HYDROLOGY K20/D33 3 PLANS

# DRAINAGE REPORT FOR GARCIA'S HONDA

RE: DRAINAGE PLAN FOR GARCIA TOYOTA RECEIVED MARCH 27, 1986
(K-20/D33)

RE: DRAINAGE PLAN FOR GARCIA TOYOTA (K20-D33) RECEIVED MARCH 13, 1986

STORM DRAIN PLAN

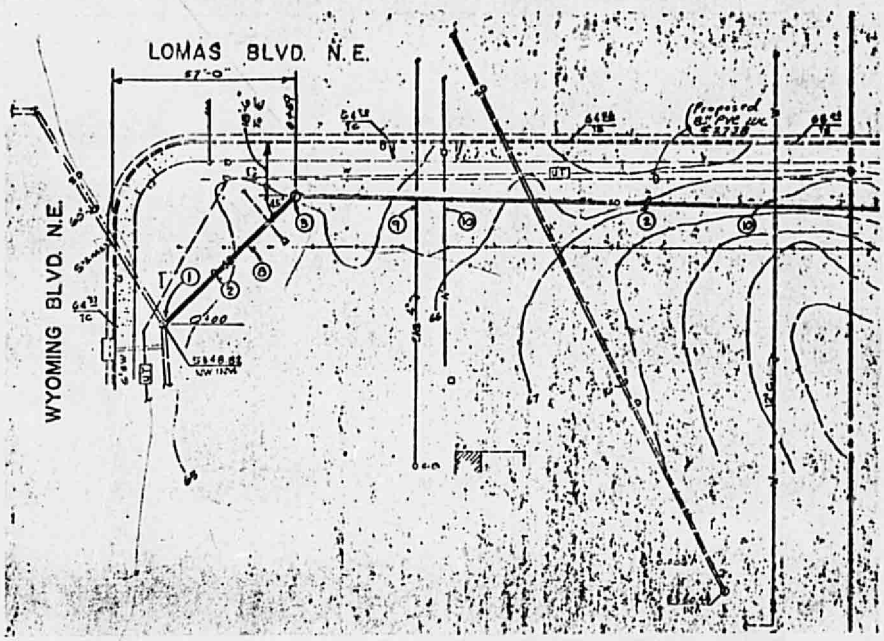
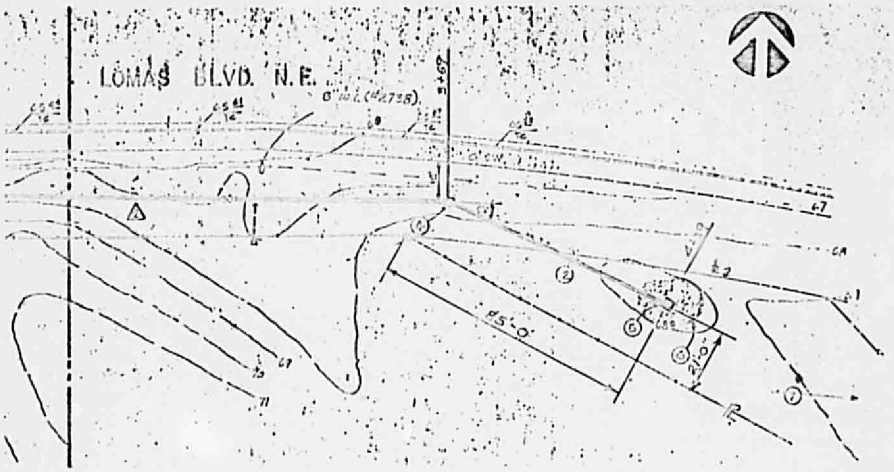
2. The following items need to be addressed pertaining to drawing C-4A.

A. Require an S.O. #19 for work in the public R/W.

B. Need a drainage covenant for the storm drain system for maintenance responsibility.

C. Need a hydraulic grade line on the profile view. Also, the table and calculations need to be submitted.

D. Please submit a section of the inlet and dumped rip-rap.

E. Require a drainage easement for the storm drain system.

2. The following items pertain to Sheet C-4A.

2A. Preliminary review of the sytem as shown on C-4A has been completed by Engineering. A letter from the Owner is requested to confirm that this will be a private system.

2B. Maintenance responsibility will be by the Owner as per 2A above.

2C. The hydraulic grade line has been added to the drawing. The computations are an addendum to the original report.

2D. A section of the single "D" inlet showing the dumped riprap erosion control has been added to the drawing.

2E. It is my understanding that the storm drain system is to remain a private system with maintenance the responsibility of the Property Owner. The portion in the Lomas R.O.W. is covered for construction by the S.O. #19 order therefore, I do not believe an easement is required.
